CDM: Recommendation Form for Small Scale Methodologies (version 01)

Date of SSC WG meeting:	16–19 June 2009, SSC WG 21
Title/Subject (give a small title or specify the subject of your submission, maximum 200 characters):	Applicability of AMS-III.Q to project activity based on existing practice
Indicative methodology to which your submission relates (refer the items of Appendix B of the Simplified Modalities and Procedures), if applicable.	AMS-III.Q version 02
Name of the authors of the query:	Mr. Thirumalavan Panchaksharam Institution: Asia Carbon Pte Ltd thiru@asiacarbon.com

Figure 1

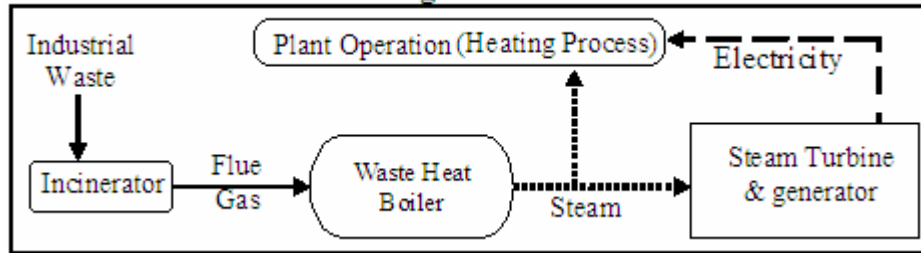
The project activity (Figure 1) is involved the installation of cogeneration system which is generating steam and electricity by utilizing flue gas from incinerator. The proposed CDM project activity encompasses the primary equipments such as Incinerator, waste heat recovery boiler (WHRB) and gen set (steam turbine + generator). The electricity generated by the project activity is partially replacing grid power. The plant still consuming some electricity from the grid.

As highlighted in the applicability, The incinerator is not an existing facility but an existing practice. The existing practice did not recover (confirmed by third party waste collector) any flue gas for energy generation. We seek clarification whether the definition of existing facility may include existing practise to ensure that the flue gas is a waste heat.

The SSC WG agreed not to recommend broadening of the methodology to projects activities where the baseline scenario is determined based on existing practice, considering the complexity involved in such project activities which will be difficult to capture under the simplified framework of small scale methodologies. The SSC WG took into account paragraph 58 of EB 47 while considering the case:

Figure 2

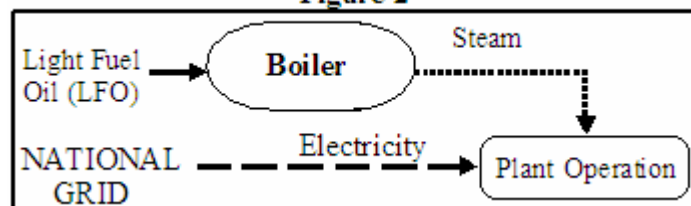
The Project Proponent (PP) is mainly involving in treatment, recycling and disposal of oily sludge, slope and industrial waste oil. The process of treatment and recycling requires steam and electricity. In baseline, the steam was produced by the fossil fuel based boiler and power was consumed from the national grid. Therefore the fossil fuel based steam generation and grid power should be considered as the baseline (Figure 2).

In absence of proposed project activity, the flue gas would have been released into atmosphere by the third party incinerator. They are incinerating mixed wastes from the various industries. Therefore, quantifying the flue gas generated from the PP's waste is quite complicated. Therefore other than point number (iii) would not be applicable.

We seek clarification on the highlighted part that the PP has financial documents to demonstrate the energy consumption in the baseline. Even though, the electricity generated by the project activity will be partially replaced the grid power. The available electricity bills are showing that the total payment made by PP for total consumption. As per the monitoring, separate meters are in place to calibrating power from grid and power generation at the project site to meet the methodology requirement.

- The proposed project activity involves "treatment, recycling and disposal of oily sludge, slope and industrial waste oil". This implies that the wastes are not only generated by the Project Participants but also derived from other sources. This would increase the uncertainty not only in fixing the baseline, but also in monitoring the project activity since the wastes received during the crediting period may vary widely in amount, composition and origin, and it will be almost impossible to distinguish what is "waste" and what is "fuel" in the incinerator/co-gen facility.

- Leakage: additional baseline fuel may be needed in the incinerator after the implementation of the project activity.
